AMENDMENT TO LAREDO SPRINGS

PRELIMINARY OVERALL DEVELOPMENT PLAN
THIS POADP AMENDS POADP #427-K PREVIOUSLY APPROVED BY THE DIRECTOR OF DEVELOPMENT SERVICES ON 10/29/04

Re: Laredo Springs Amendment

MDP # 427-M

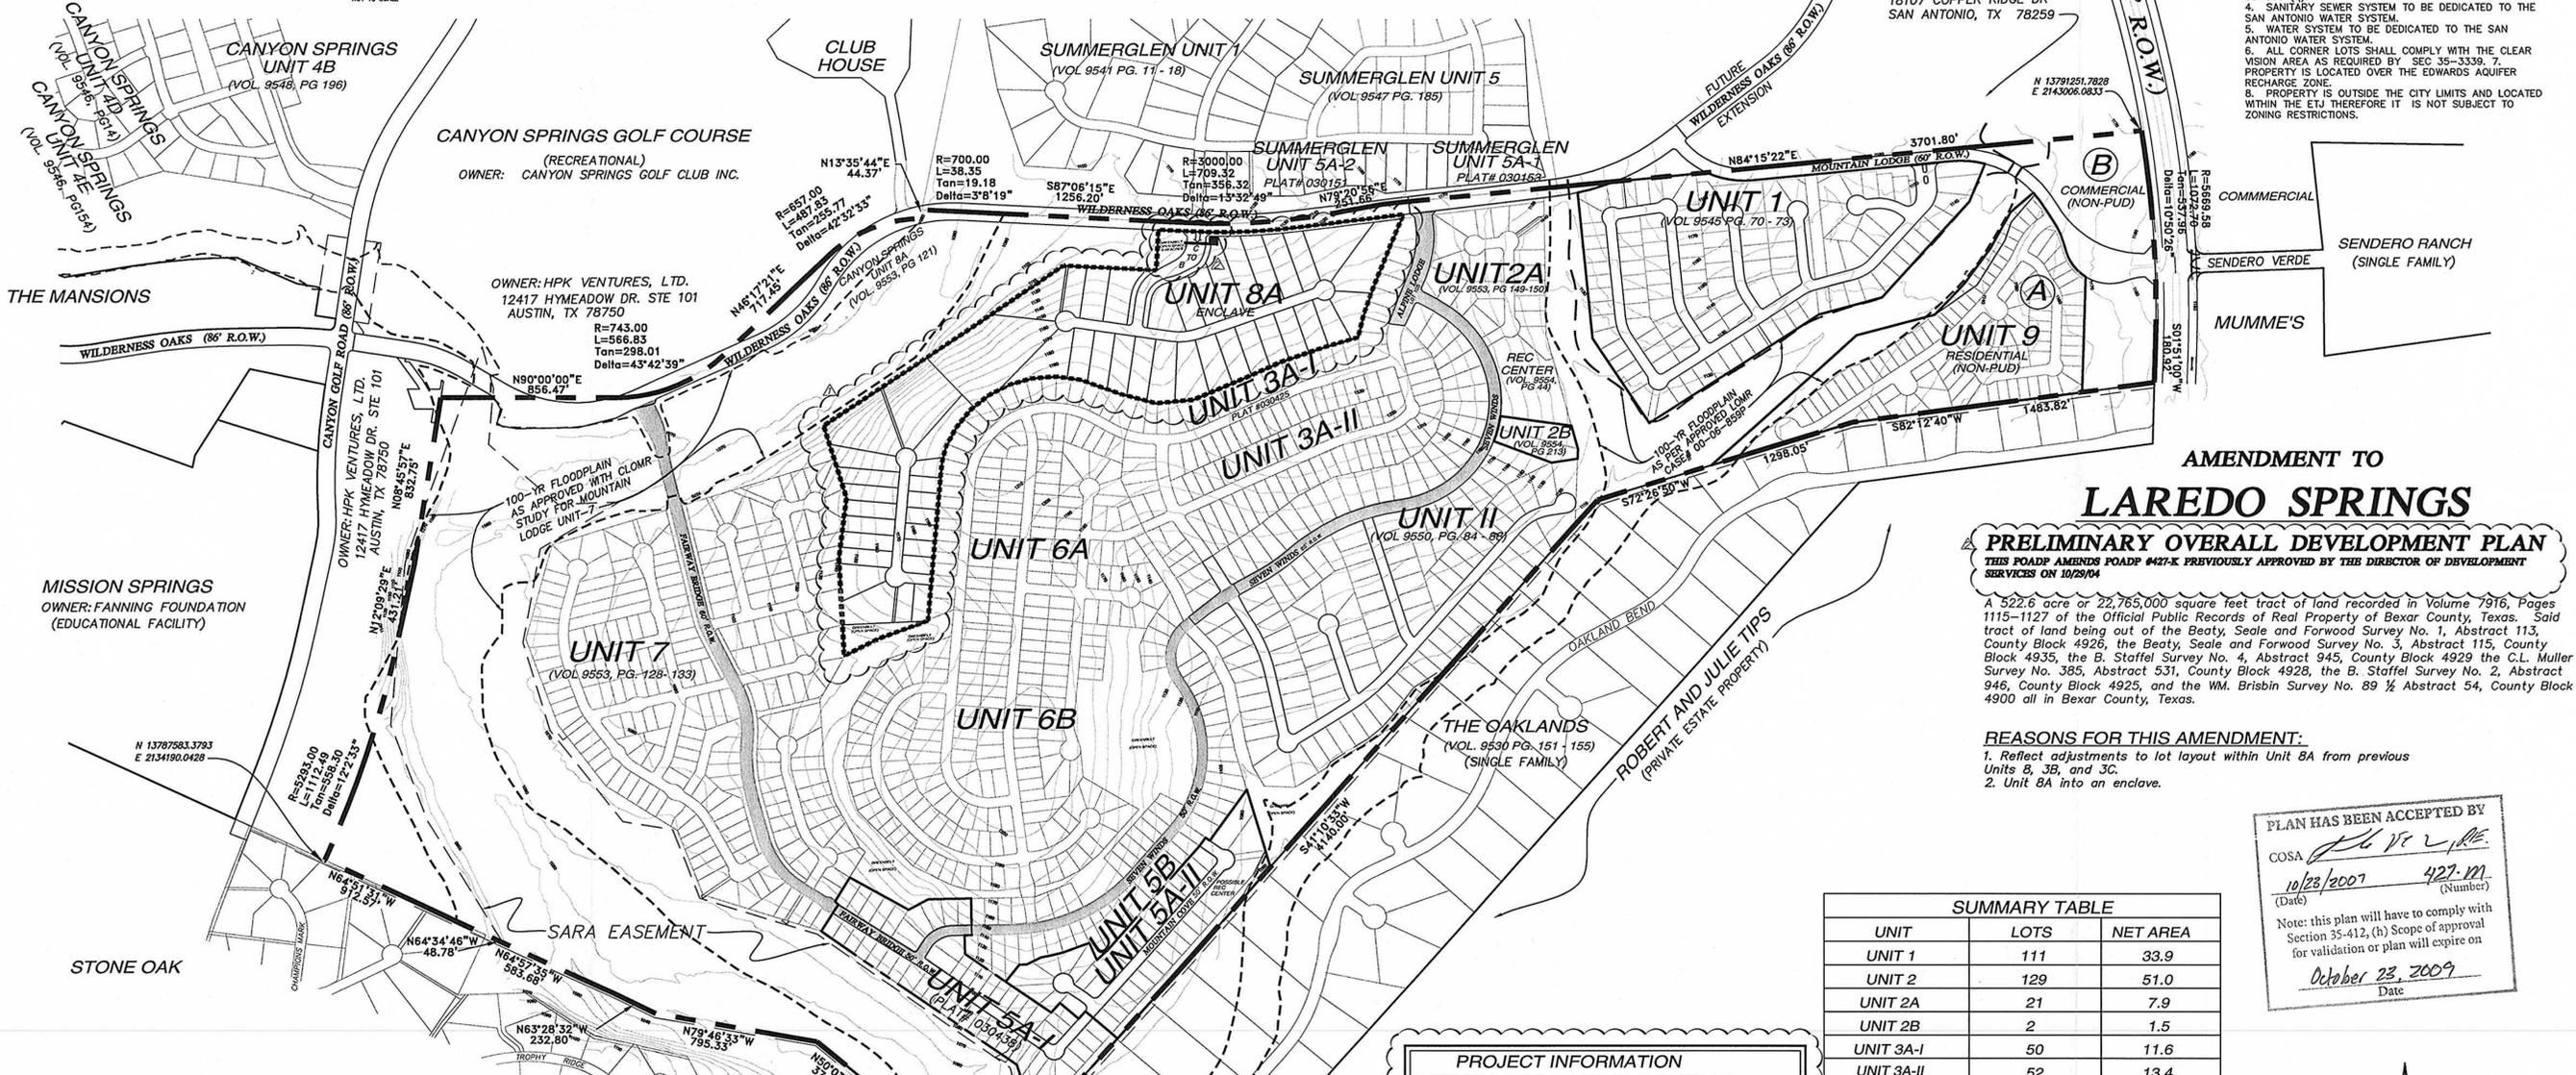
Laredo Springs is a proposed subdivision that is covered by a Vested Rights Permit, VRP 02-01-061, which does not require a parks dedication. However, Unit 8A is not covered by this permit and therefore is subject to UDC standards. Unit 8A contains thirty-one lots not covered by VRP 02-01-061. UDC Section 35-503, Table 503-1 states that single-family development is required to provide one acre of park/open space per every seventy dwelling units. The requirement for this development is 0.42 acres. This subdivision provides 0.49 acres of park/open space dedication outside of the One Hundred Year Floodplain.

- The parkland provided shall be shown as “Park” or “Open Space” on a plat; UDC §35-503(e) *Designation of Parkland*.
- The parkland provided is dedicated to the Home Owners Association.
- The instruments creating the Home Owners Association are provided by the second application for plat approval; UDC §35-503(e) *Designation of Parkland*.
- Parkland dedication must be platted by the second phase of residential development; UDC §35-503(f) *Development Phasing*.
- Parkland in the Floodplain Area shall comply with UDC §35-503(d) (2) *Parkland in Floodplains or Water Features*.
